**VALUE ENGINEERING STUDY**  
**OF**  
***KY 30***

**ITEM NUMBERS: 11-278.24 & 11-278.27**

**Laurel & Jackson County, Kentucky**

**April 9-13, 2007**

#### AS PROPOSED CROSS SECTION

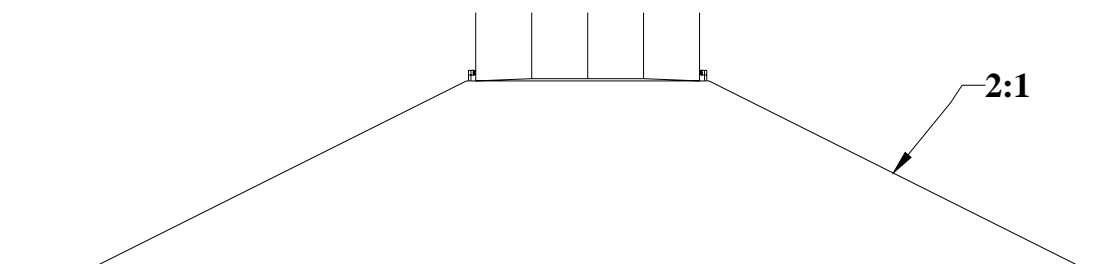
Fill heights less than 10' high will use a 4:1 fill slope and is increased to a 2:1 with fill heights above 10'. There are areas where the 4:1 has been used with fill heights above 10'.

A review of the earthwork quantities indicates large waste volumes on both sections of roadway.

Raise the proposed grades. The obvious advantages of raising the profile grade would be a reduction in the unclassified excavation quantities and a decrease in the amount of waste materials. This raising of the profile grade will reduce the imbalance in the unclassified and waste quantities and would be a cost savings.

The disadvantages of raising the profile will be a redesign of the plans, an increase in the length of drainage structures in the fill sections, such as the cross drain pipes, culverts and the bridge at Moore's Creek. Also to be considered is the possible need for additional right-of-way and the need for extra guardrail on fill sections were the additional depth of fill requires protection as the fill slopes change from a 4:1 condition to the steeper 2:1 slopes.

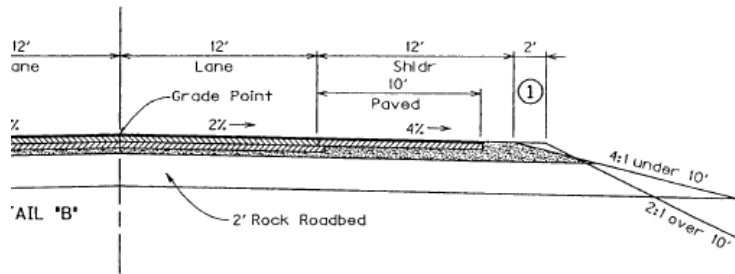
Construct the project with a “False Cut” in the fill sections over 10’. This alternative would place excess fill outside the clear zone to create a small berm as shown in the drawing below.

This alternative would reduce the amount of excess material that will have to be hauled off by the contractor as well as reduce the amount of guardrail required on the projects. Ideally, this typically would be used between two closely spaced cut sections to allow the storm water to run along the outside swale to the first opportunity to drain down the outside slope. After a detailed review of the cross sections, drainage considerations and right-of-way constraints this alternative was **DROPPED FROM FURTHER CONSIDERATION.**

**NORMAL SECTION**

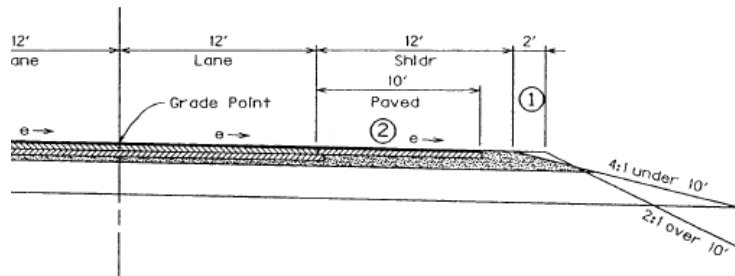
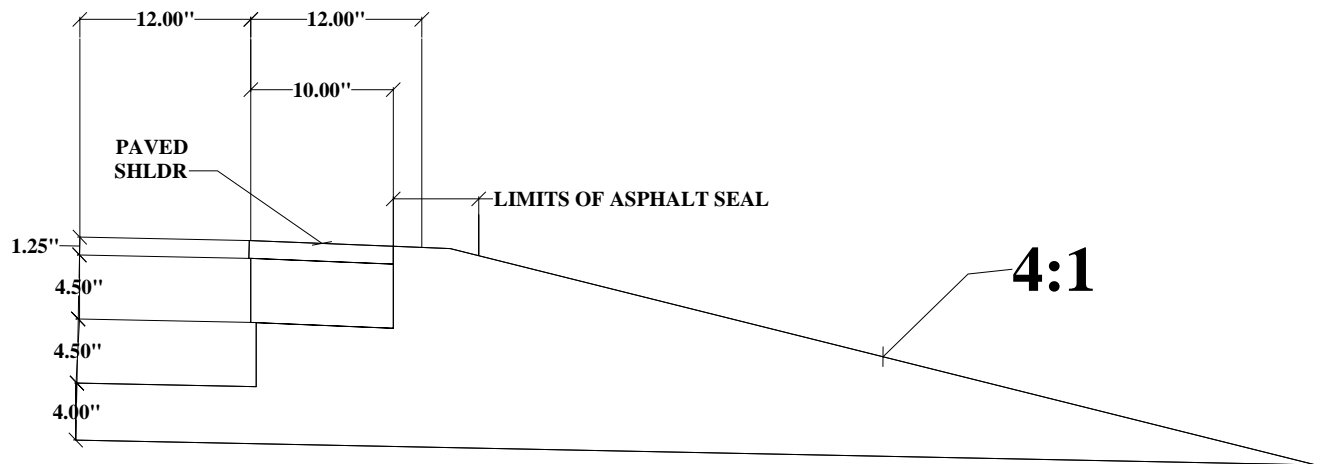
The “As Proposed” pavement design used the Maximum Asphalt Design as shown below.

#### *Value Engineering Alternative Number 1*

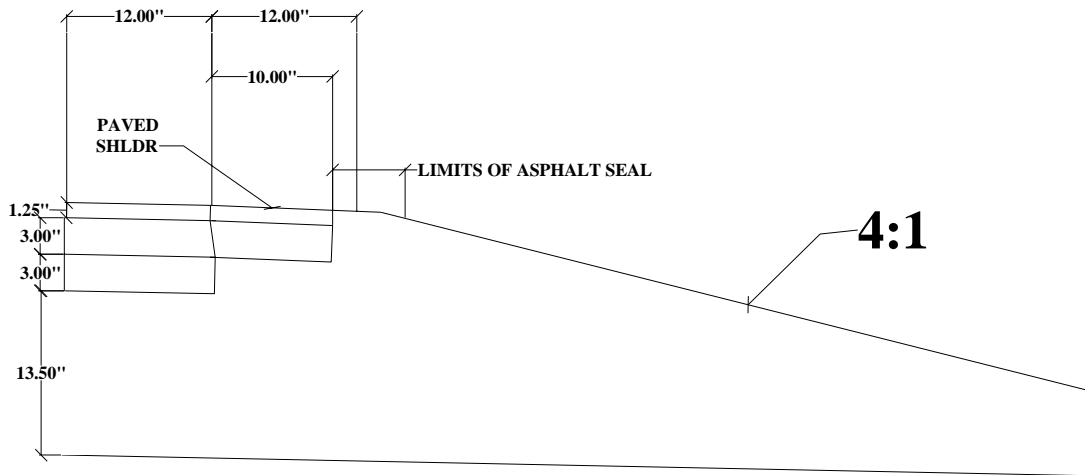
Construct 2-12' lanes with 13.5" crushed stone base, 6" structural asphalt, and a 1.25" asphalt surface and 2-12' shoulders with full depth crushed stone base, 4.5" of structural asphalt and 1.25" surface asphalt. (Maximum Aggregate Design)

#### **ELEVATION**

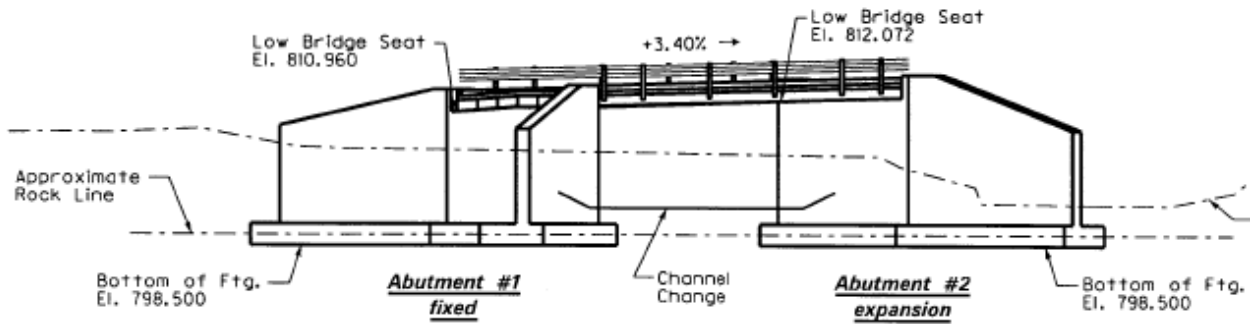
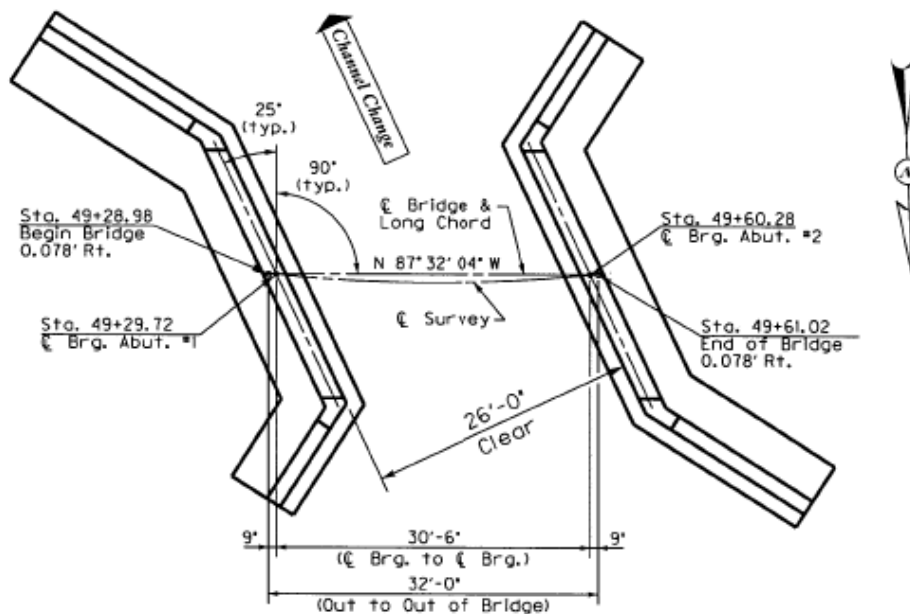
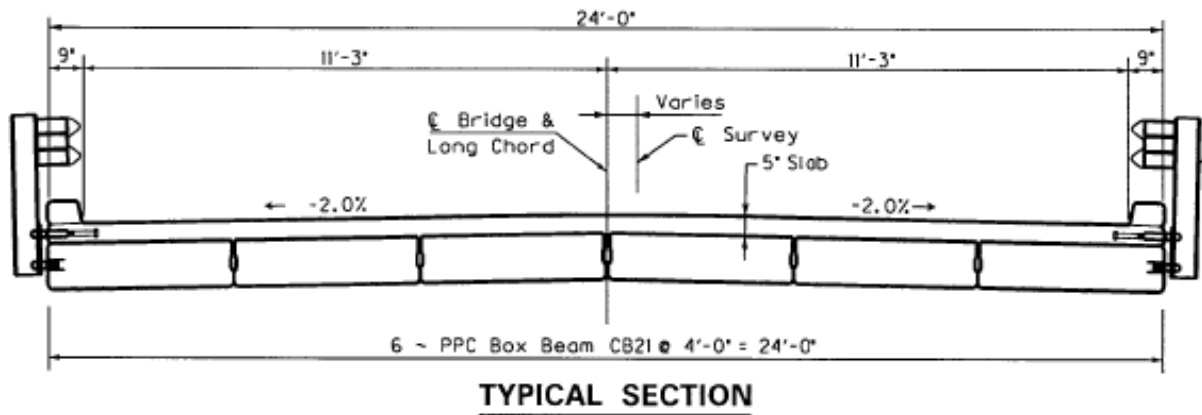
The Value Engineering Team recommends replacing the Double 14' x 7' RCBC with the bridge shown below.

*30'-6" CB21 PPC Box Beam, Simple Span  
 HS25 Live Load ~ 30'-6" Shoulder Width @ Bridge  
 7° Skew Rt. ~ 22'-6" Bridge Roadway Width ~ 2:1 Fill Slopes*

The economic analysis indicated this would be a slightly more expensive alternative than the "As Proposed." The center wall of the box culvert may trap and collect debris that may ultimately block the channel, causing flooding. With the wider opening of a bridge and nothing to trap debris there will be less risk of flooding with the bridge alternative.
